## HISTORIC AND DESIGN REVIEW COMMISSION

Agenda Item No: 26

**HDRC CASE NO:** 2016-453  
**ADDRESS:** 629 NOLAN  
**LEGAL DESCRIPTION:** NCB 547 BLK 19 LOT 17 AND 18  
**ZONING:** R-6 CD H  
**CITY COUNCIL DIST.:** 2  
**DISTRICT:** Dignowity Hill Historic District  
**APPLICANT:** Russ Tillery/Paradise Decks  
**OWNER:** Richard Garcia  
**TYPE OF WORK:** Construction of a side deck  
**REQUEST:**

The applicant is requesting a Certificate of Appropriateness for approval to construct a side deck to the historic structure at 629 Nolan.

# ELEVATION

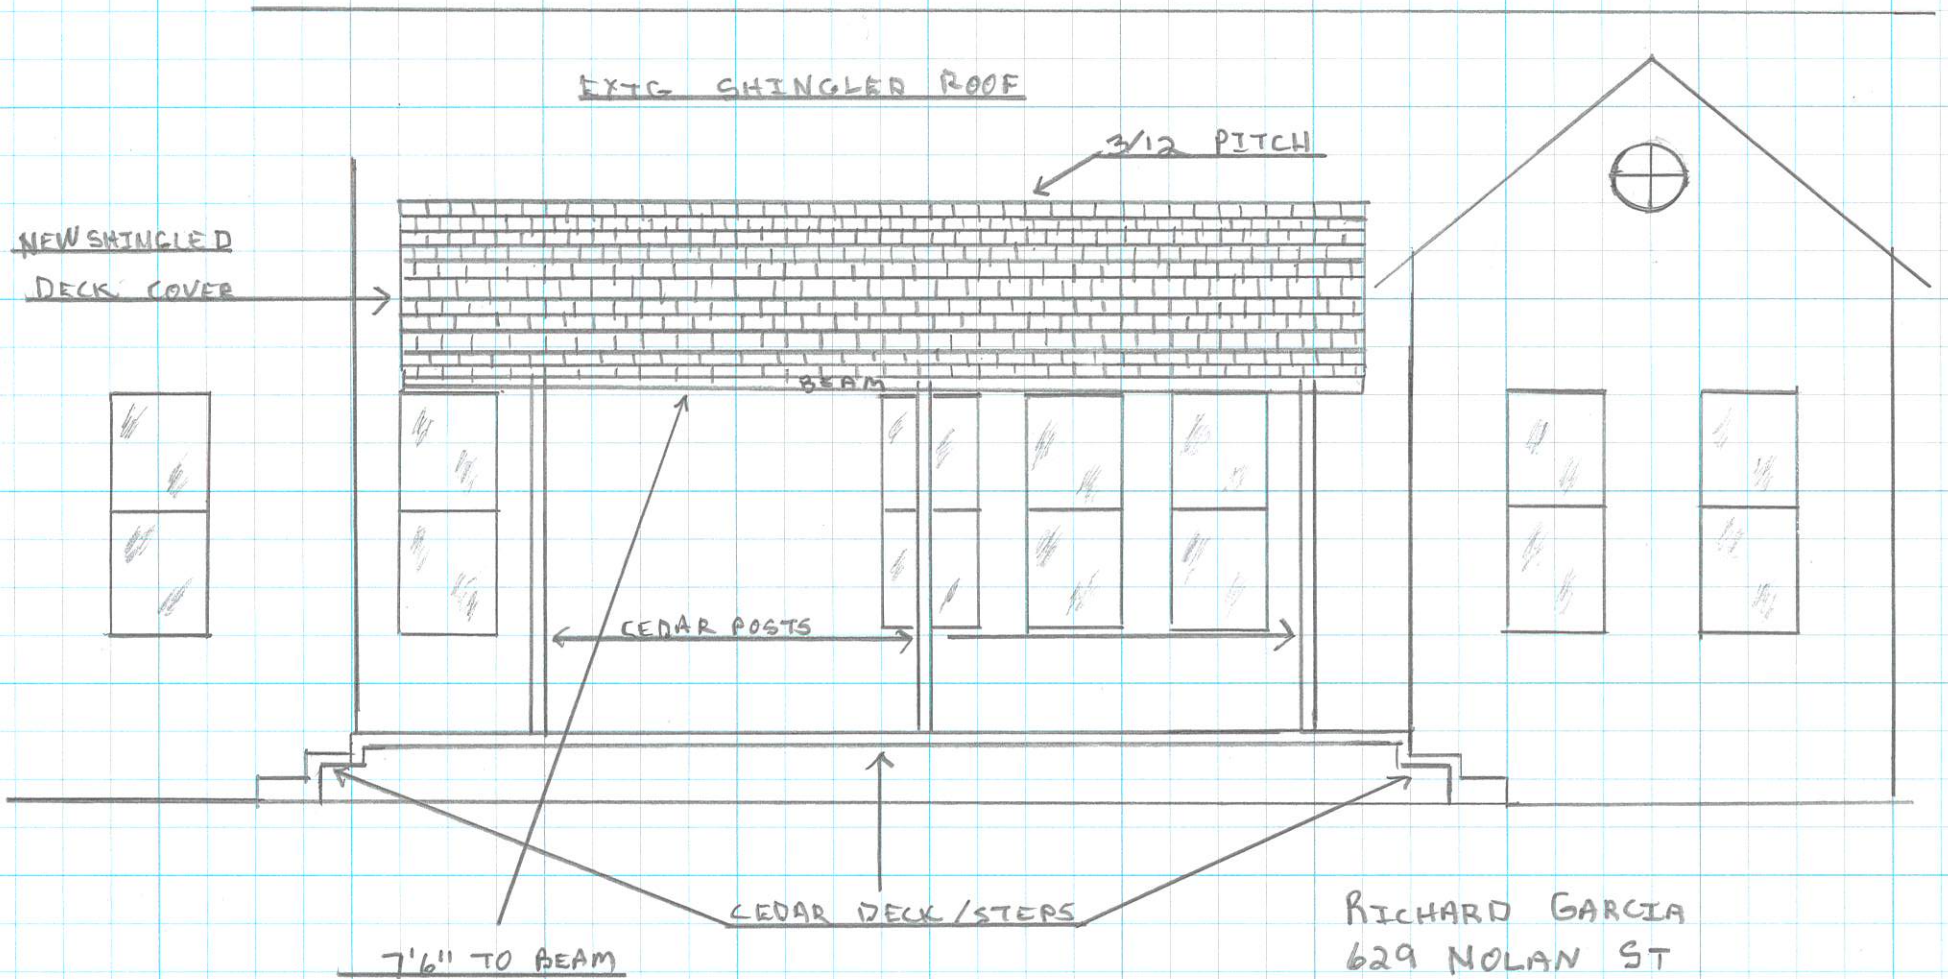
- c. In regards to a porch roof, the applicant has not provided a detail on the covering. Staff recommends the applicant provide a detailed elevation drawing of the proposed cover prior to receiving a Certificate of Appropriateness.

Staff recommends approval based on findings a through d with the stipulation that the applicant provide a detailed elevation drawing of the proposed cover prior to receiving a Certificate of Appropriateness.
